DCBX – building on Joe’s proposal

Manoj Wadekar

- **Proposal from Joe Pelissier:**

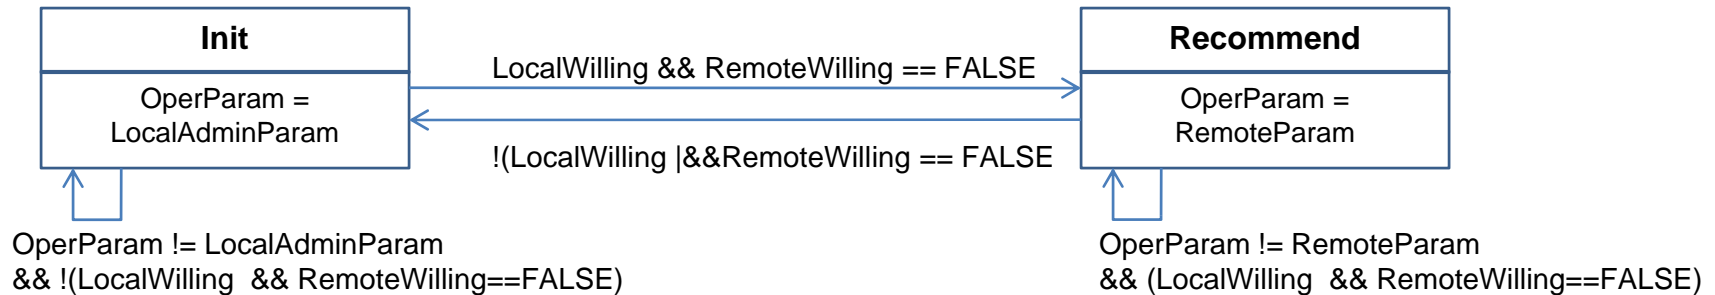
- **Works well**

- **Few suggestions**

- Editorial generalizations
 - to allow definition of single SM in 802.1Qaz
 - 802.1Qbb (PFC) and 802.1Qaz (ETS) can provide functions that are invoked in common state machine
- Adding “Ready” state – important for End Stations
 - Need to decide when DCB feature can provide indication to applications (e.g. FCoE, iSCSI) that link provides desired characteristics and on which priorities etc.

Editorial generalization

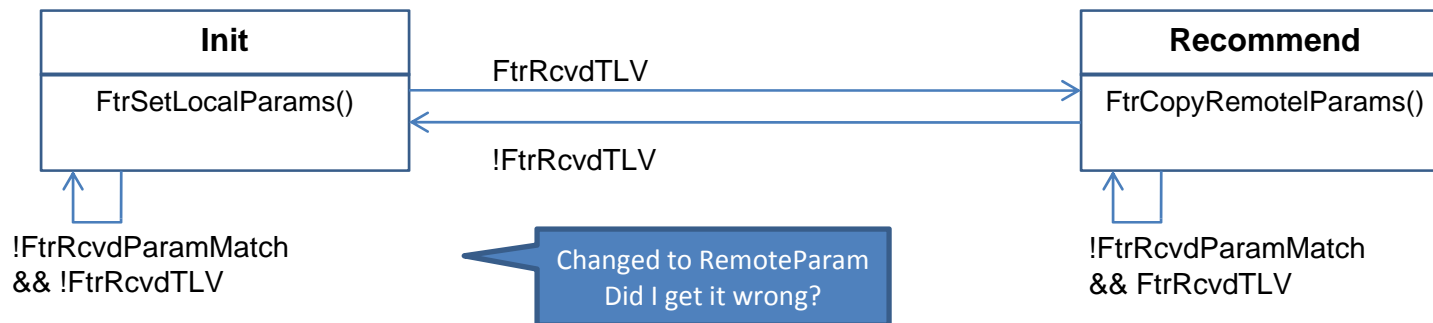
- **FeatureRcvdTLV:**

- Rcvd TLV from peer,
 - (LocalWilling && RemoteWilling == FALSE) for symmetric TLV: defined in 802.1Qbb
 - (LocalWilling && RV == TRUE) for asymmetric TLV: Defined in 802.1Qaz

- **FtrRcvdParamMatch:** Rcvd TLV from peer, OperParam == RemoteParam
- **OperParam = LocalAdminParam: FeatureSetLocalParams:** both in 802.1Qbb and az
- **OperParam = RemoteParam: FeatureCopyRemoteParams:** both in 802.1Qbb and az

Changed SM with “Ready” & “Both Ready”

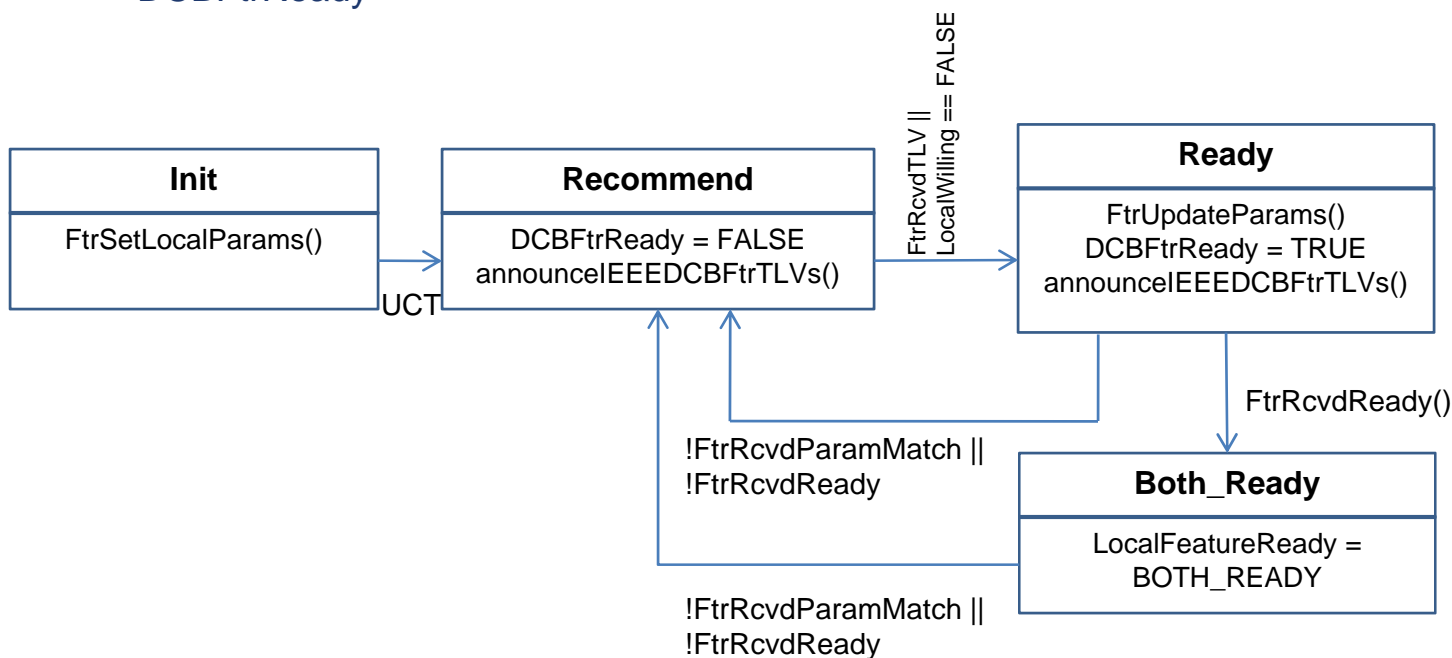
- FtrUpdateParams(): if (LocalWilling == TRUE) FtrCopyRemoteParams(); else {}
- FtrRcvdReady(): RemoteReady == TRUE
- announceIEEEEDCBFtrTLVs(): Update local LLDP MIB to send update to peer

- LocalFeatureReady: Indication to local entity whether feature is ready

- DCBFtrReady
